Re: <u>557 Highland Avenue</u>, Needham Heights, Massachusetts (the "Property")

RESPONSES TO TOWN OF NEEDHAM PLANNING BOARD COMMENTS AT JUNE 7, 2022 PUBLIC HEARING (557 HIGHLAND AVENUE)

RESPONSE TO GPI COMMENTS ON TRANSPORTATION IMPACT AND ACCESS STUDY (557 HIGHLAND AVENUE)

From: Sean Manning, PE, PTOE Matthew Duranleau, PE Re: Response to Transportation Impact and Access Study Traffic Peer Review Comments dated May 27, 2022

Turning	Movement	Diagrams
---------	----------	-----------------

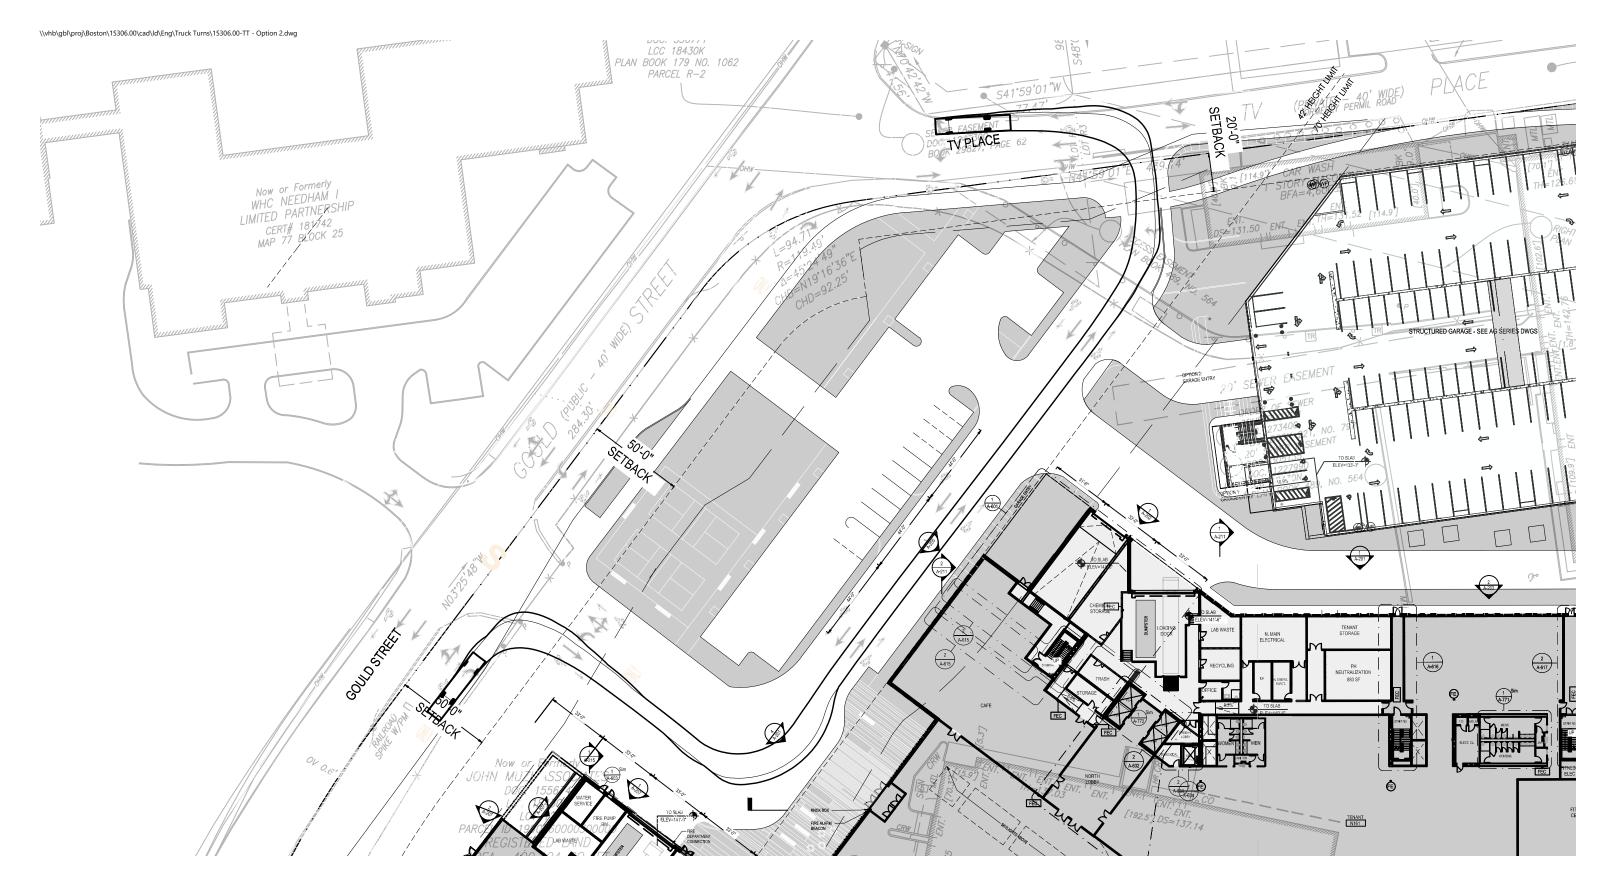
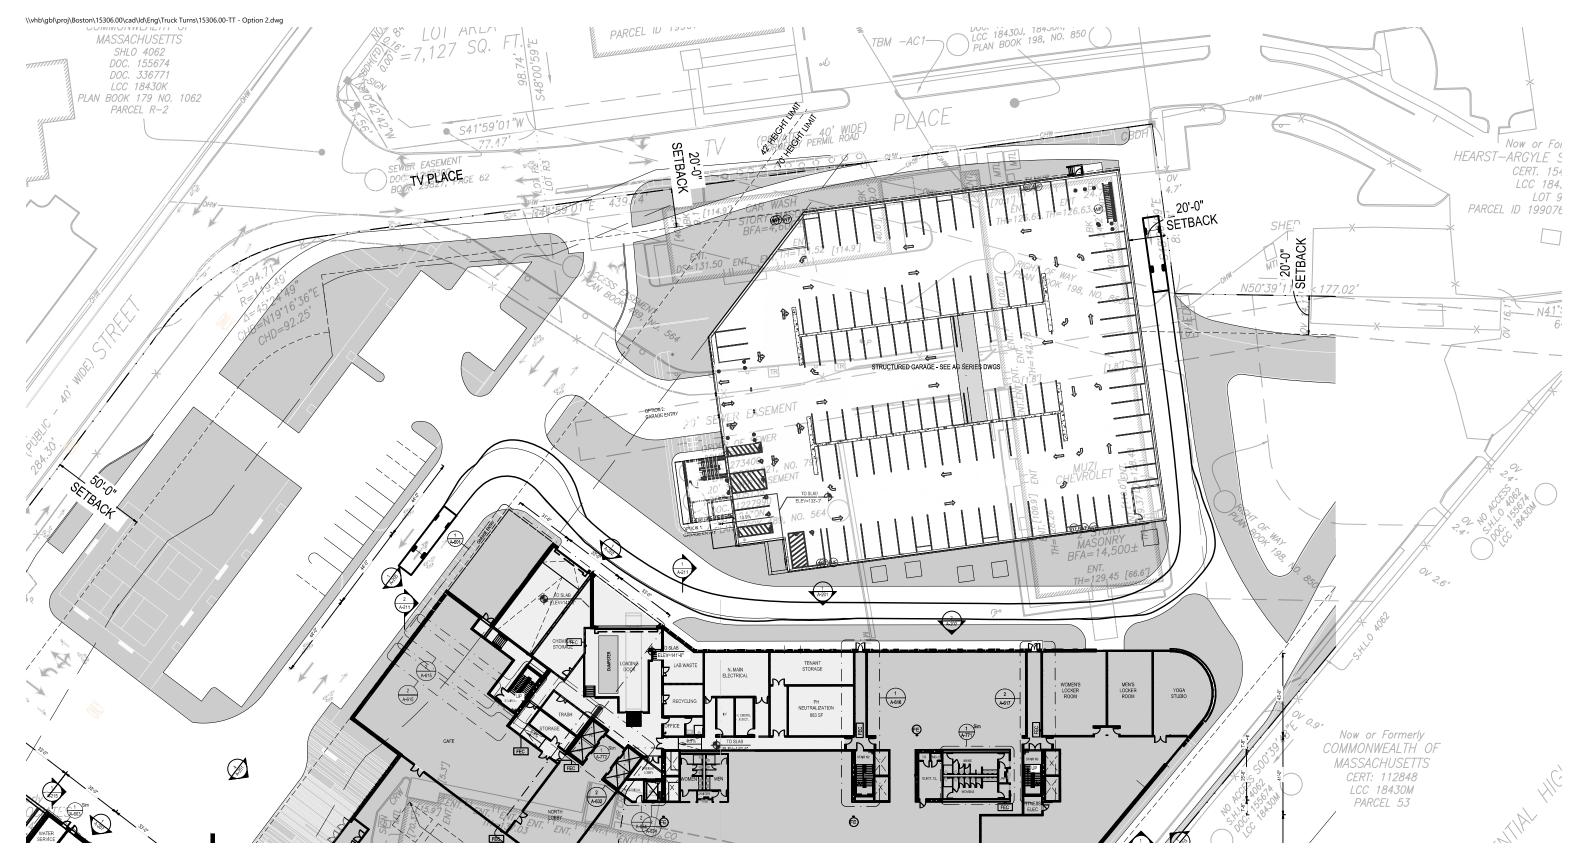
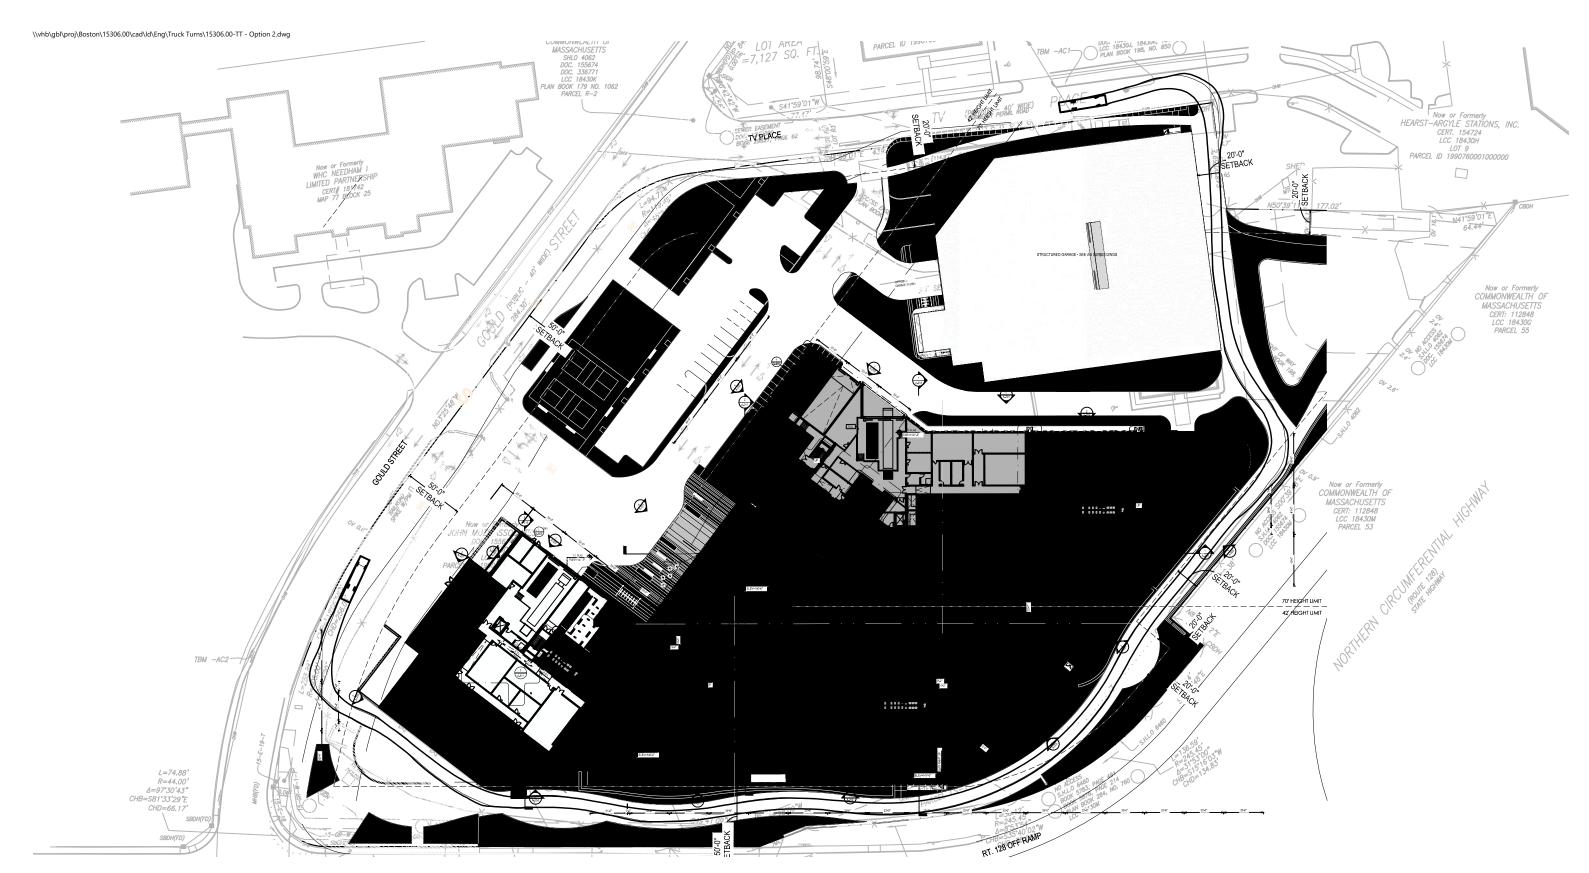
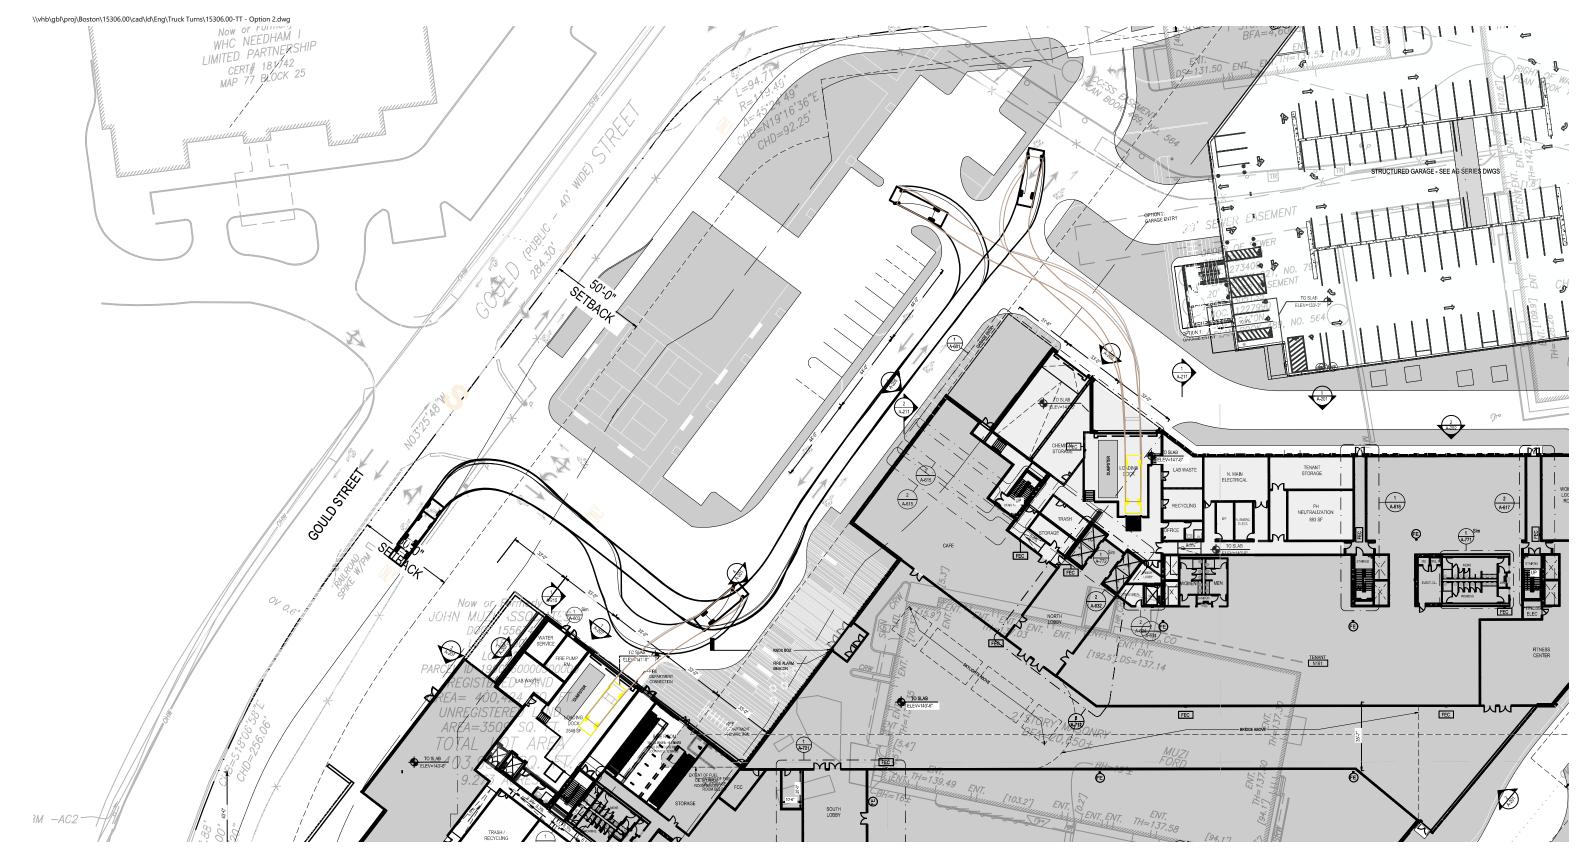
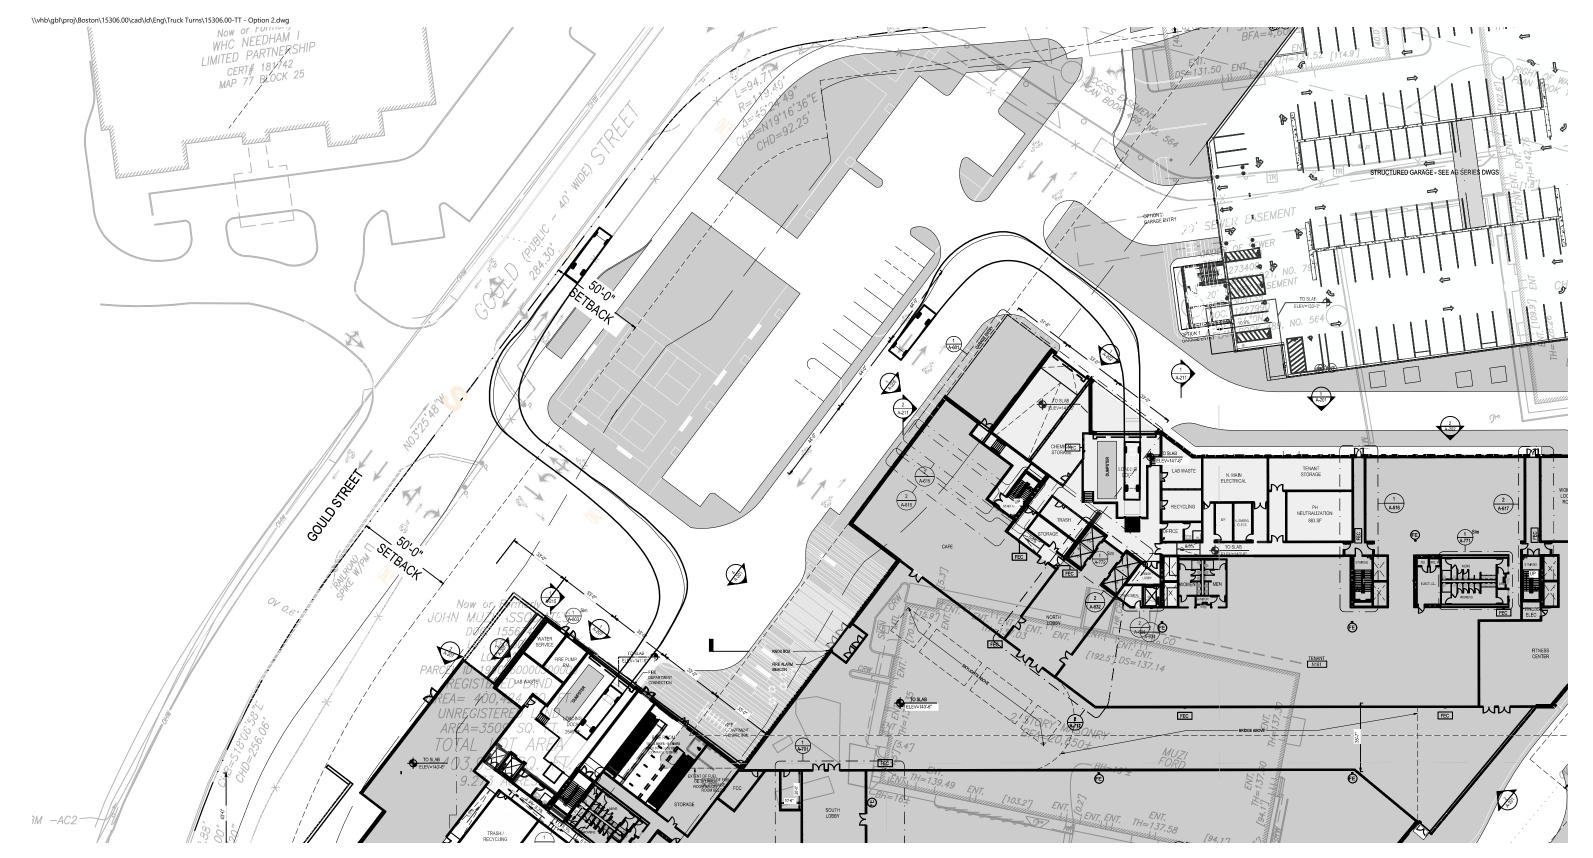
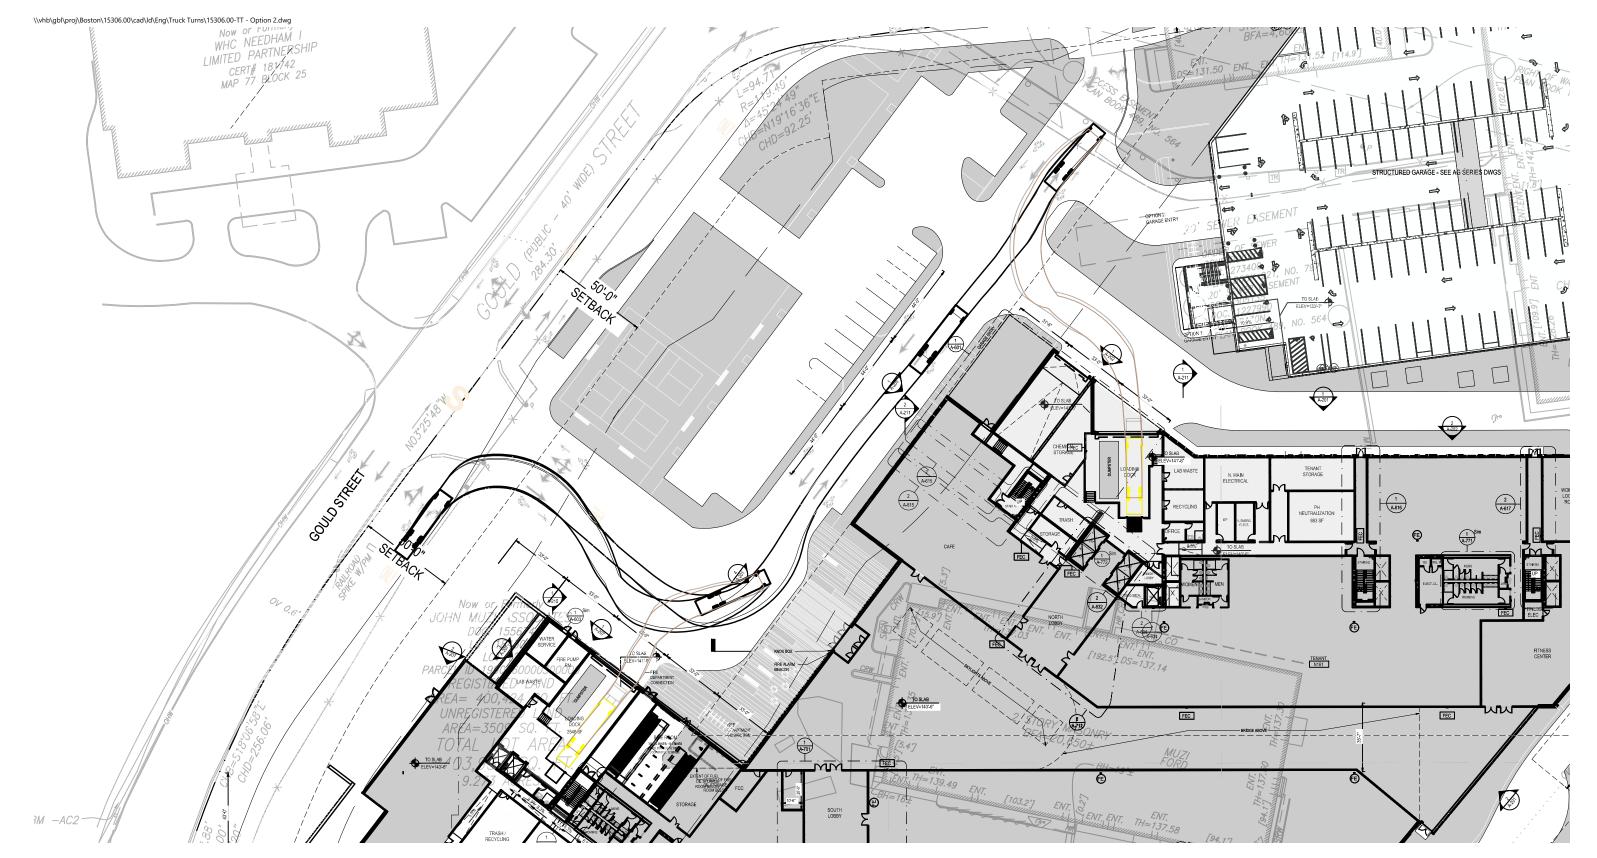
<u>Applicant Response:</u> Turning diagrams within the site have been studied and are provided in the Attachments to this memorandum. The emergency vehicles as well as delivery vehicles can safely access and navigate the site.
